**ADDENDUM AND RESPONSE
TO RFI FOR DA/251/2013/A,
DA/1188/2017 AND DA/1191/2017**

**20 PACIFIC HIGHWAY,
BENNETTS GREEN**

ADDENDUM AND RESPONSE TO RFI FOR DA/251/2013/A, DA/1188/2017 AND DA/1191/2017 – 20 PACIFIC HIGHWAY BENNETTS GREEN

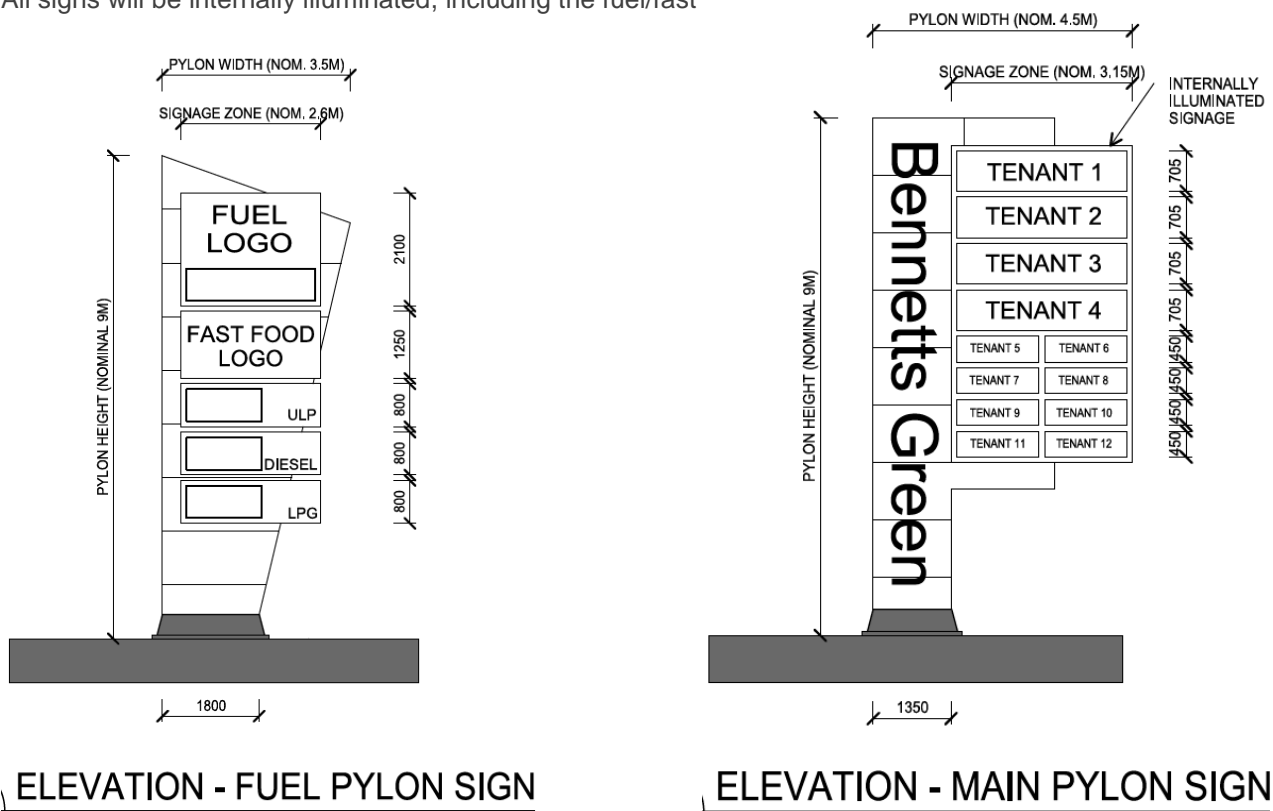
The Section 96(2) application as lodged proposed:

- **two x 12m** high pylon signs on the Pacific Highway;
- **one x 12m** high pylon sign on South Street.

The signage locations as lodged are illustrated below.

The addendum now proposes the following pylon signs:

- **three x 9m** high pylon signs on the Pacific Highway;
- **one x 9m** high pylon sign at the Lake Street entry.

The third sign the Pacific Highway relates to the proposed service station and associated fast food tenancy.

Note that the South Street pylon sign has been removed, and will be replaced with a small directory sign, discussed in the following section;
